ADNOC GAS HABSHAN & BAB CONTROL SYSTEMS UPGRADE (PACKAGE 1) PROJECT NO. 0405323						  				
			COMMENTS RESOLUTION SHEET										
Document Title:			PIPING & INSTRUMENTATION DIAGRAM 13-C-101B TURBINE DRIVE & AUX. - RAIN 2 EARLY THAMMAMA 'B' (HABSHAN)				AGP Response Code			Prepared By:	VK		
Document No:			13-00-211		Revision No:	B	1. Revise and Re-submit		3. Approved		Checked By:	DV	
AG Ref. No:			ADNOCGP-WTRAN-002750		Date:	29-Jul-2024	2. Approved with comments	✓	4. For Information only		Approved By:	YVR	
SN	Reference		COMPANY Comments	CONSULTANT Response	COMPANY Resolution								
	Page No.	Clause No.											
1	1	Process Comment	Why straight length requirement could not be specified for Orifice Flow Element? Why awaiting vendor info? BTME to clarify.	Noted and straight length is updated.									
2	1	Process Comment	Why HOLD? This HOLD point is not justified.	Noted. Note 14 is updated and hold is deleted from P&ID.

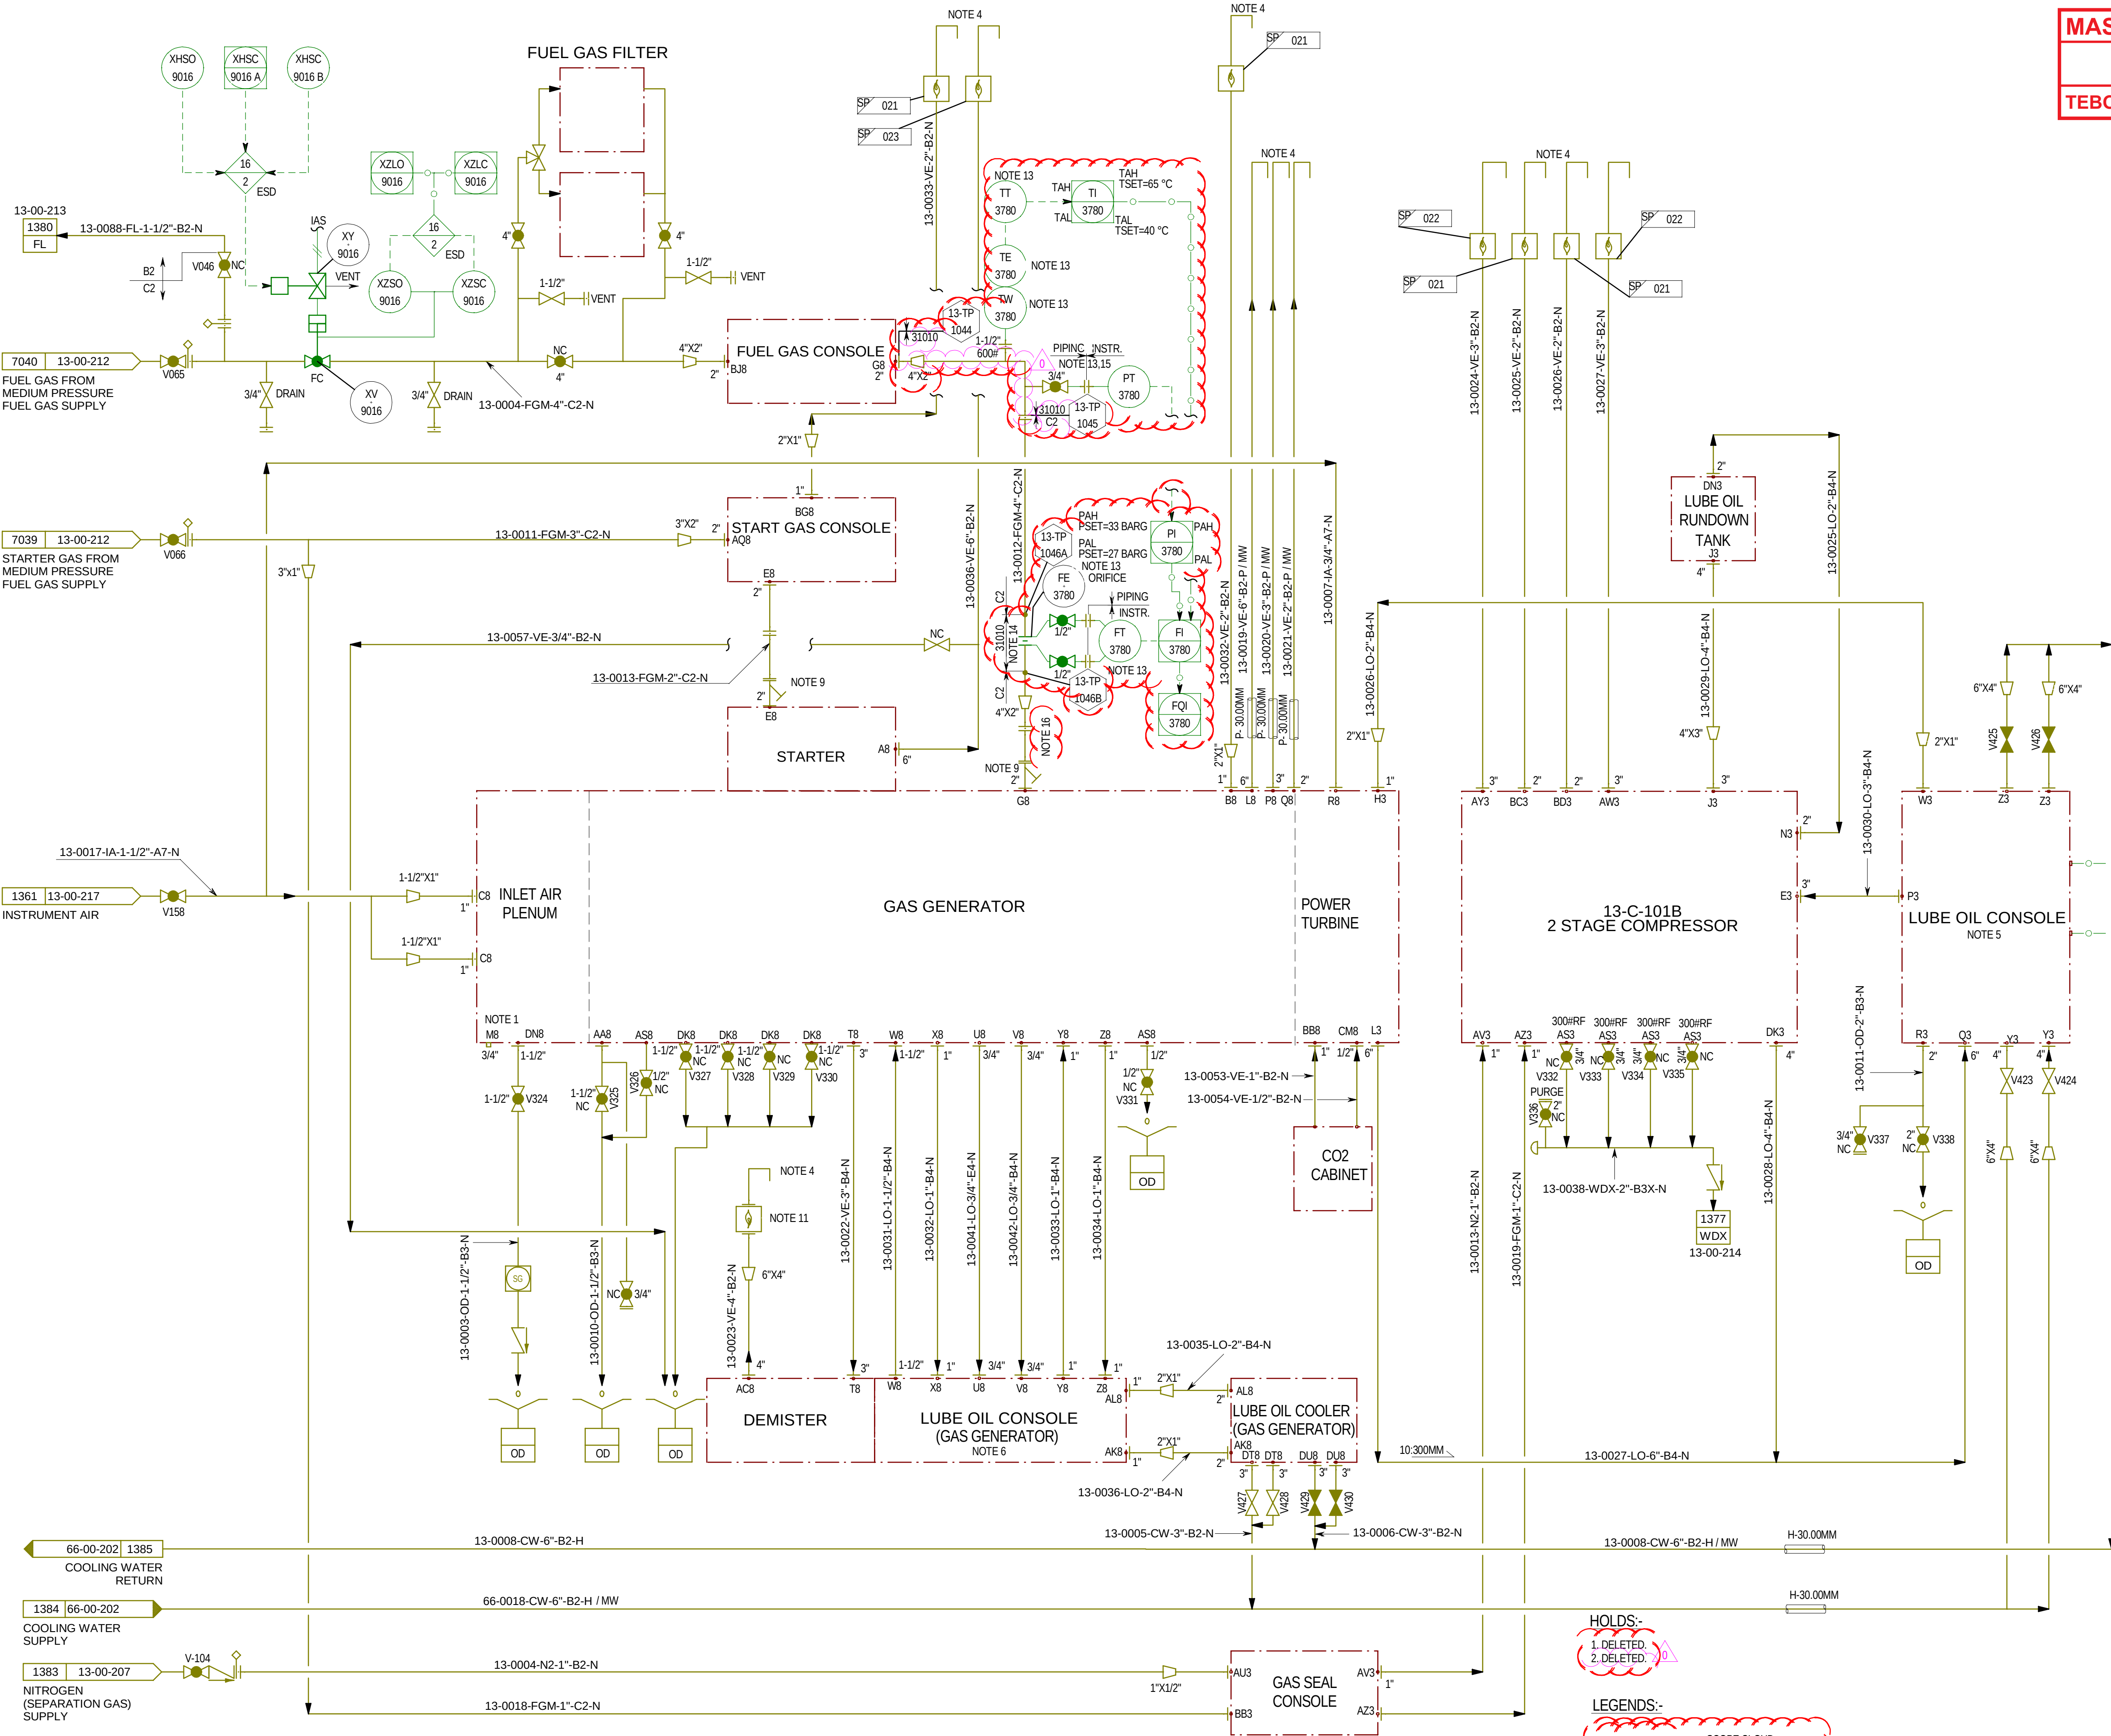
3	1	Process Comment	Please refer to general comments provided in unit.no 013 (Doc.no. 13-00-209) - 5323P1-TL-1395	Noted and all the relevant comments are updated in the P&ID.									
4	1	-	-	Following changes are made in P&ID w.r.t. Rev.B submission as per piping/instrumentation inputs. 1. Tie-in Point 13-TP-1044 & 1045 location is updated as per piping input. 2. Flange rating for TW-3780 is updated as 600# as per piping Input. 3.Note 17 added.
